Access Compliance Report

(Curb Ramps)

Intersection ID: 8417	Main Street: POINSETT_ST	Cross Street: WAINWRIGHT_AV	Location: SE
ADA ID: 2D77C7C68E00	Ramp Type: PerpDiag	Initial Pass/Fail: Fail	Overall Compliance: No
Codes/Mitigation Info/Possible Solution		Field Measurements/Component Compliance	
Severity Score: 12.5

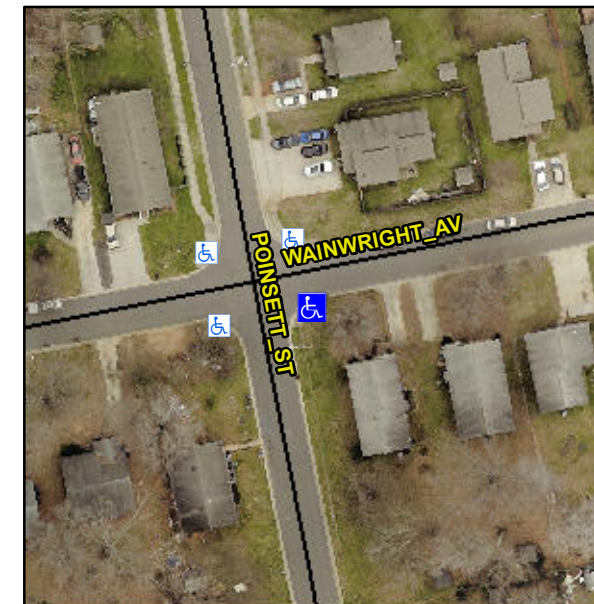
Not Found, R304.5.3

Compliance	Description	Data	Compliance	Description	Data
N/A	Ramp Length (in)	58.5	Yes	Ramp Slope (%)	6.8
Yes	Ramp Width (in)	48.0	No	Ramp XSlope (%)	5.1
N/A	Flare Type LT	N/A	N/A	Flare Type RT	N/A
N/A	Flare Slope LT (%)	N/A	N/A	Flare Slope RT (%)	N/A
N/A	Flare Traversable LT?	N/A	N/A	Flare Traversable RT?	N/A
N/A	Landing Length (in)	N/A	N/A	DWS Provided?	N/A
N/A	Landing Width (in)	N/A	N/A	DWS Contrast?	N/A
N/A	Landing Slope (%)	N/A	N/A	DWS Length (in)	N/A
N/A	Landing X Slope (%)	N/A	N/A	DWS Full Width?	N/A
N/A	Landing Curb? (Y/N)	N/A	N/A	DWS Offset (in)	N/A
N/A	Shared Landing?	N/A			
N/A	Gutter Ponding?	N/A	N/A	Gutter Slope (%)	N/A
N/A	Gutter Lip Ht (in)	N/A	N/A	Gutter X Slope (%)	N/A
N/A	Painted X Walk1?	No	N/A	Painted X Walk2?	No
	X Walk 1 Direction	To N		X Walk 2 Direction	To W
N/A	X Walk 1 Width (in)	N/A	N/A	X Walk 2 Width (in)	N/A
	X Walk 1 Slope (%)	9.8		X Walk 2 Slope (%)	1.5
	X Walk 1 X Slope (%)	0.2		X Walk 2 X Slope (%)	6.8

N/A	Ramp inside XWalk1?	N/A	N/A	Ramp inside XWalk2?	N/A
	Road Slope (%)	3.3	N/A	Clear Space?	N/A
	Road X Slope (%)	4.8	N/A	Clear Space to XWalk (in)	N/A
N/A	Any Obstructions?	N/A	N/A	Storm Grate/Utility Hazard?	N/A
	Obstruction Type			Storm Grate/Utility Type	
		N/A			N/A
			Yes	Surface Condition? (G/P)	Good

Remove & Replace Curb Ramp With Two New Directional Ramps or Equivalent.
